RADIOLOGICAL EFFLUENT TECHNICAL SPECIFICATIONS

(RETS) IMPLEMENTATION - FORT ST. VRAIN

NUCLEAR GENERATING PLANT

Published September 1983

Figure 2. Fort St. Vrain Radioactive Gaseous Discharge Pathway.

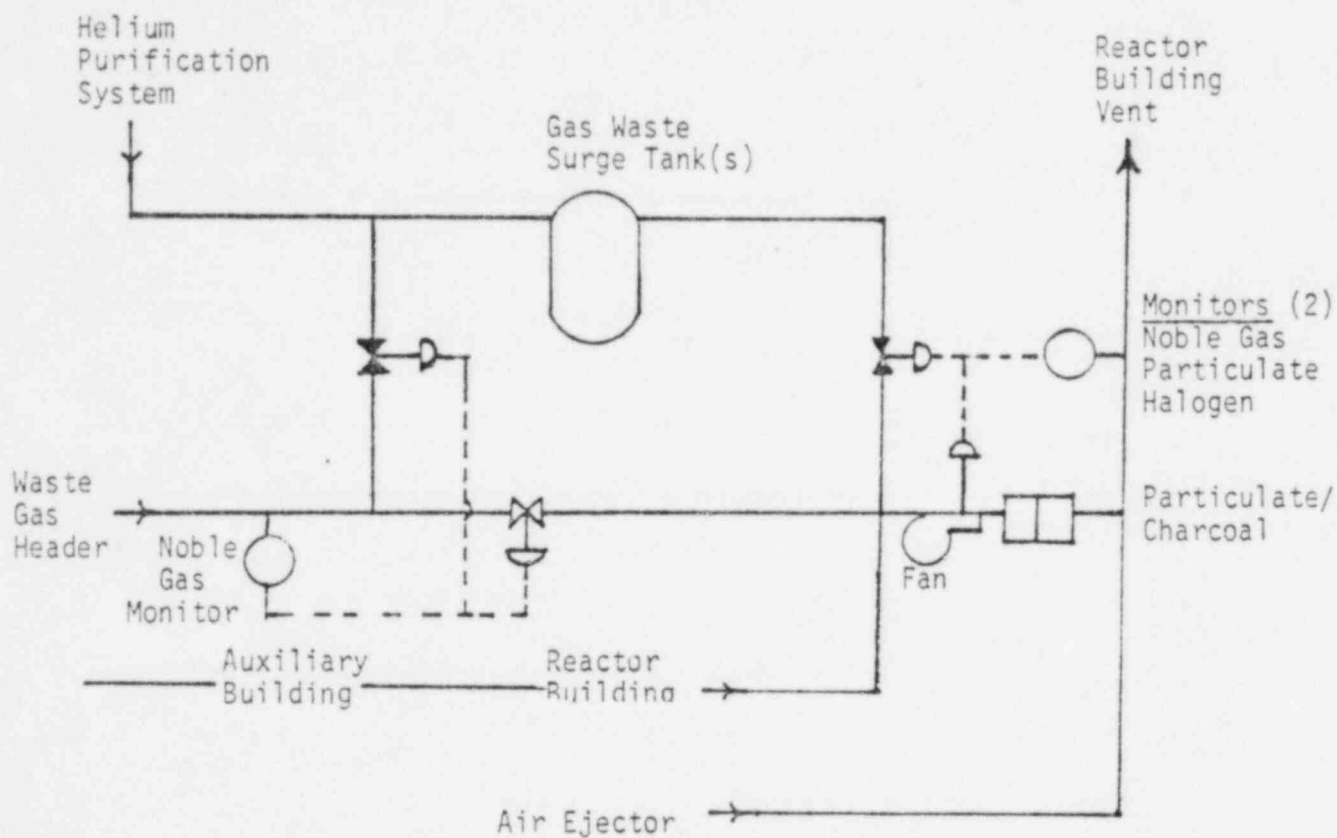
The reactor building vent is the common radioactive gaseous effluent release point for several feed streams as shown in Figure 2. Figure 3 shows the location of the liquid and gaseous effluent release points.

Discharges from the gas waste header are normally continuously released via the reactor building vent. High activity at the gas waste header

noble gas monitor will automatically transfer the discharge to the gas waste surge tank for batch release.

Except for air ejector discharge, all normal releases of radioactive gases shall be processed through the reactor building ventilation exhaust particulate filters and charcoal adsorbers.
